ASSESSMENT REPORT

Section 75W Modification Modification of Oakdale Central Concept Plan and DHL Logistics Hub Project, Horsley Park

Figure 4: WSEA SEPP Transport and Arterial Road Infrastructure

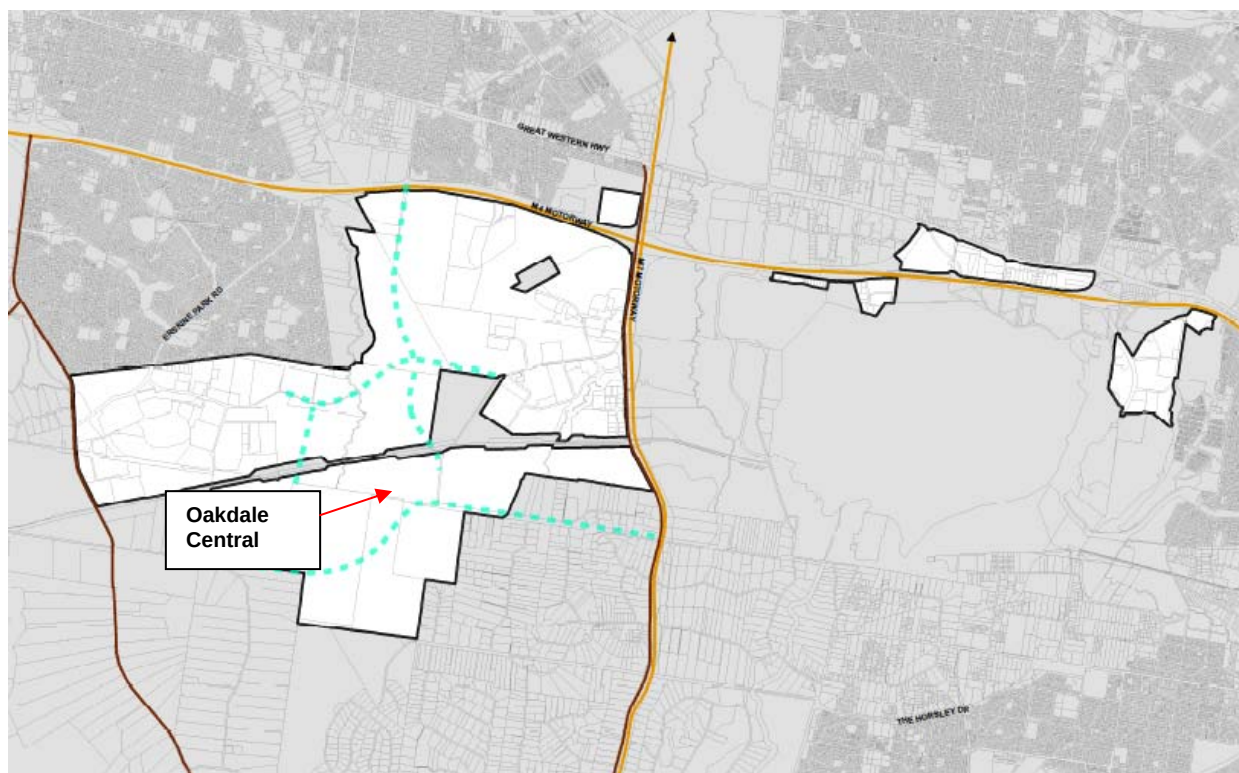
The WSEA SEPP identifies an indicative alignment for the link road network consistent with the Link Road approval (refer Figure 4). That is, the Archbold Road extension is somewhere in the middle of Option B and Option C.

Blacktown City Council raised concerns that Goodman's north-south link road alignment does not match the WSEA SEPP Transport and Arterial Road Infrastructure map indicative alignment. Council's main concern is that Goodman's alignment impacts Transgrid's land to the north-east of the site. Following discussions with the Department, Goodman amended their plans to better reflect the WSEA SEPP.

Figure 5: Proposed Concept Plan

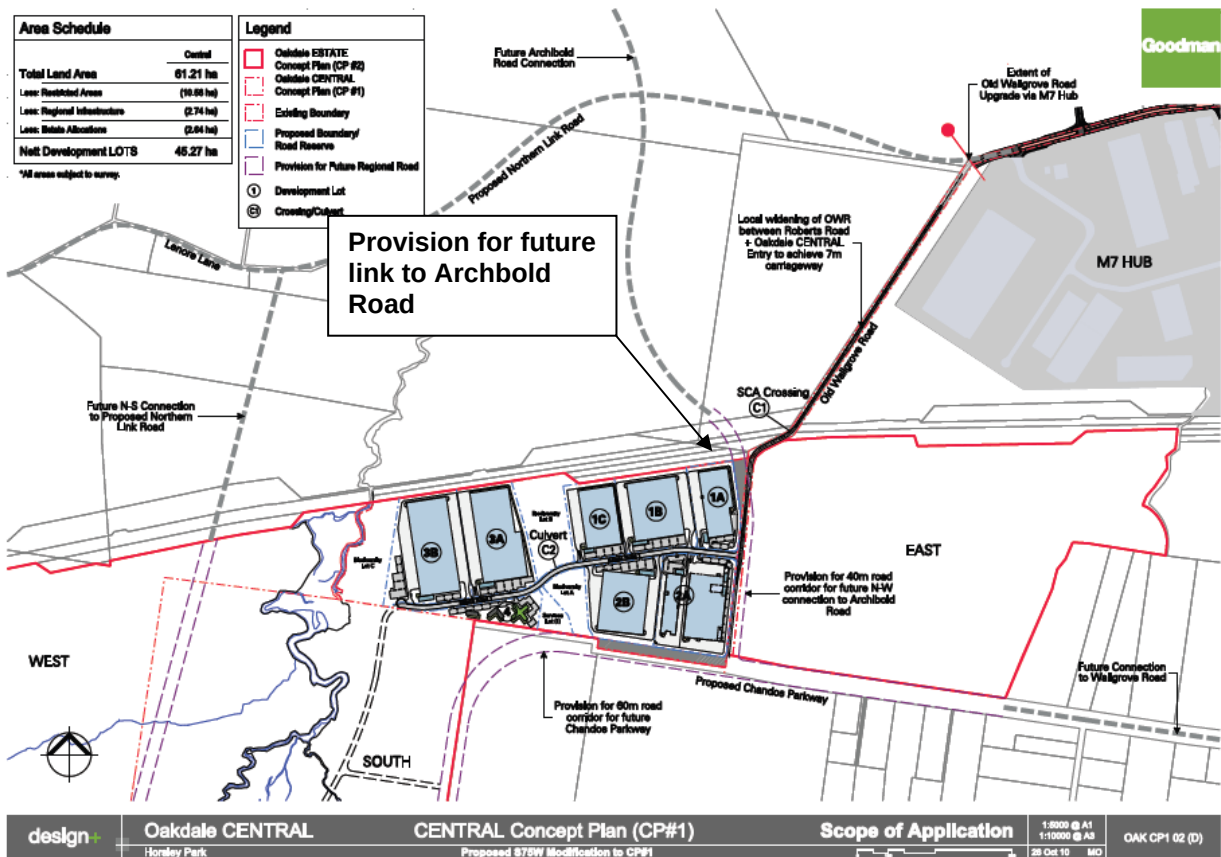
Roads – refer Figures 5 and 6	Goodman is seeking to modify the approved Project and Concept Plan to: - delete two of the proposed future north-south connections to Archbold Road, leaving only the alignment along the current alignment of Old Wallgrove Road to the east of the site, in accordance with the WSEA SEPP; - reduce and realign internal roads from four estate roads to a single central estate road, rather than running along the northern boundary (and ultimately forming part of the future link road), will be located off Old Wallgrove Road and will run in an East / West direction bisecting the estate; and - upgrade of a 0.5km section of Old Wallgrove Road from the Sydney Catchment Authority (SCA) crossing to the estate entry road to facilitate access to the revised estate entry location.
Subdivision – refer figure 5	Goodman propose to adjust subdivision boundaries to: - increase development allotments by two – through the subdivision of Lot 3 (as approved) into two lots (proposed lots 3A and 3B) and conversion of the conservation lot on the top of the hill to a developable lot; - reduce conservation allotments by one; - create a single estate road allotment (Estate Road 1 with a 23m wide corridor) rather than 3 and provision of 2 regional road allotments

As discussed above, the now commenced WSEA SEPP provides an approved north-south and east-west regional road alignment for the 'southern link'. Therefore Goodman, as well as providing revised drawings to accommodate the proposed Chandos Parkway, propose to modify the project by removing the other two now superfluous north-south corridors as well as revising the internal road layout.

The Department considers the modification to be consistent with current strategic planning work for the area and allows for the provision of future regional roads.

Figure 6: Proposed DHL Project Plan

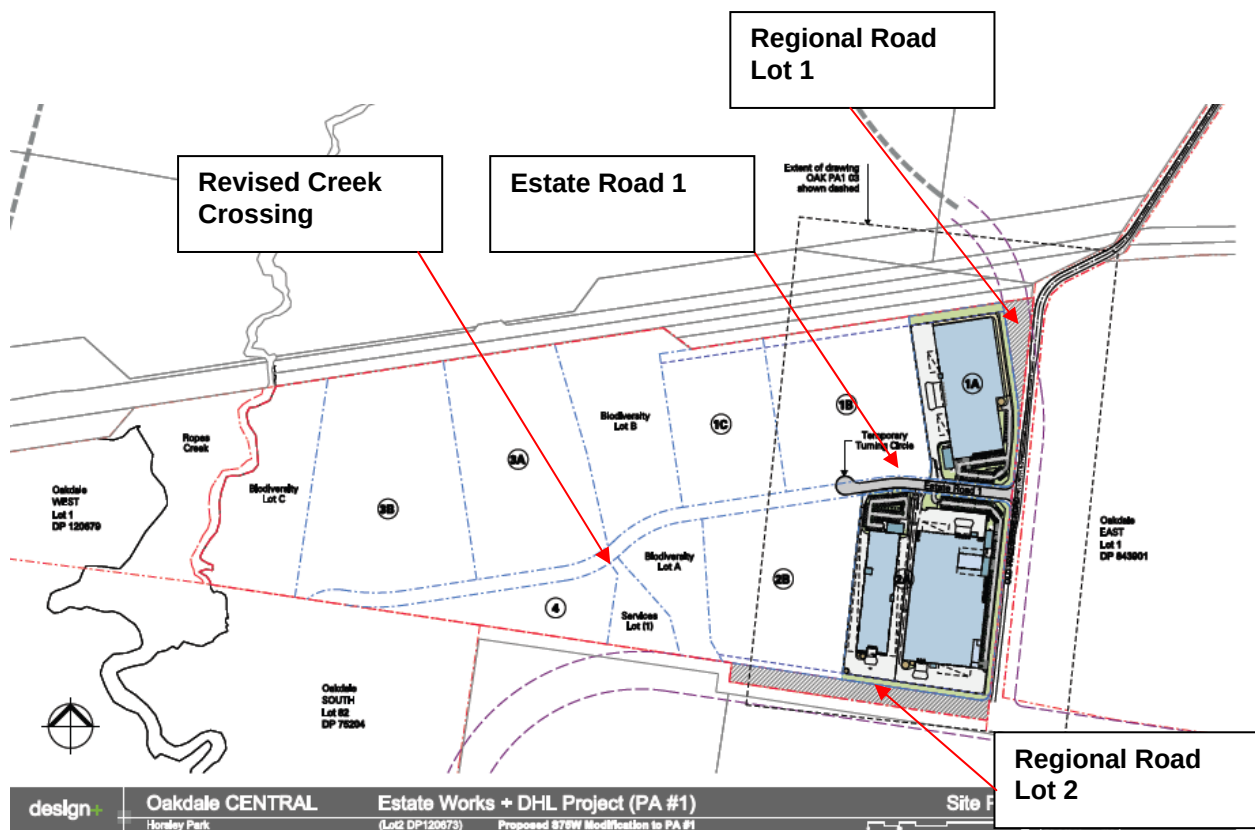
Creek crossing	As the internal road layout will comprise of a single road running through the middle of Oakdale Estate, the proposed creek crossing will be relocated some 300m to the south of the approved crossing (refer Figure 6).
DHL facility	The building layout has been adjusted in response to the revised road layout as well as to better serve DHL operational requirements (refer Figures 6 and 7). The proposed DHL facility is similar to that described in the EA with the main differences being as follows: <u>Warehouse 1 (Lot 1A)</u> • Building envelope moving slightly north and east and rotated 180 degrees so that the hardstand is on the opposite side to the public road. • Warehouse 1 is to reduce in size from 20,000m² to 19,520m² with a single sided hardstand instead of a double. • The office space will be reduced by some 120m². <u>Warehouse 2 (Lot 2A)</u> • Building footprint moving some 20m to the east and 50m to the west. The approved project allowed for buildings 1 and 2 to act as a single facility if required. The new road alignment bisects these two buildings so, to better serve DHL operational requirements, the proposed modification separates warehouse 2 into warehouses 2 and 3 so that these two can act as a single facility if required. • Approved as a 32,530m² warehouse the modification comprises of a 24,650m² (Warehouse 2) and a 9,291m² warehouse (Warehouse 3). With a minor increase in site and building area. • Building 2A was to have a double sided hardstand, Warehouse 2 is to now have hard stand at each end of the building, while Warehouse 3 is to have double sided hardstand. • Warehouse 2 will be air-conditioned and include a dangerous goods store which would comprise of full height pre-cast panels with 4 hour fire rating. <u>In addition</u> • External finishes changing from precast concrete panels to concrete dado with metal deck cladding • Rather than constructing all estate roads during stage 1, Goodman are seeking to construct the 260m long portion of the new estate road only. The temporary access is no longer required.

NSW Office of Water – raised no concerns in relation to the change of creek crossing location provided the revegetation of the riparian area is not less than the currently approved amount of 4.27ha.

Figure 8: Proposed staging

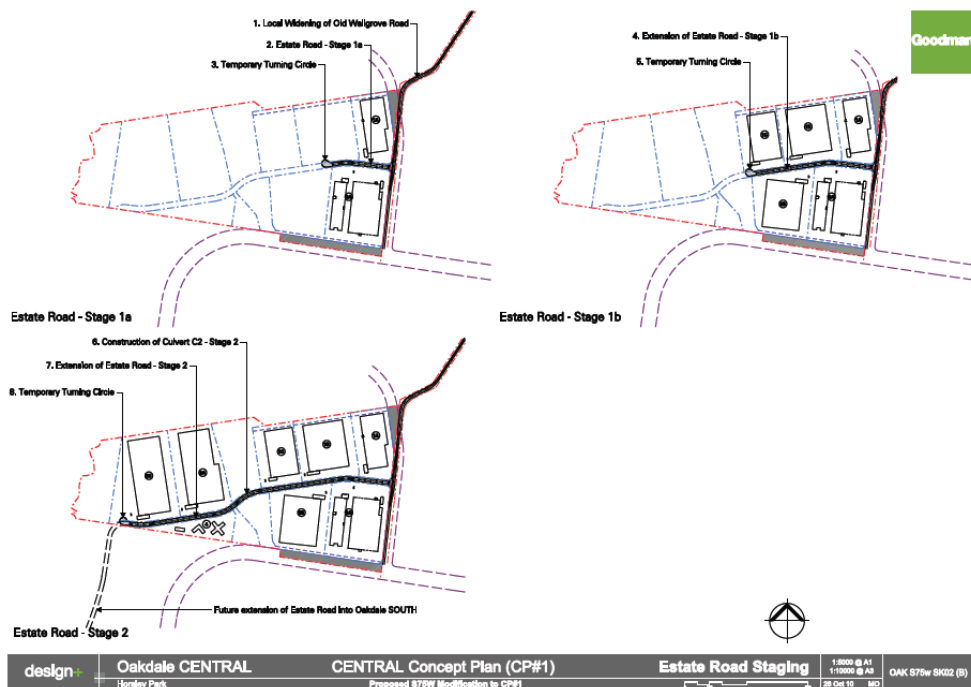
Goodman is also seeking approval to stage the construction of the internal roads, commencing with the construction of the 260m road to access DHL (See Figure 8). Detailed design and construction of the remainder of the road would occur as the estate progressively developed.
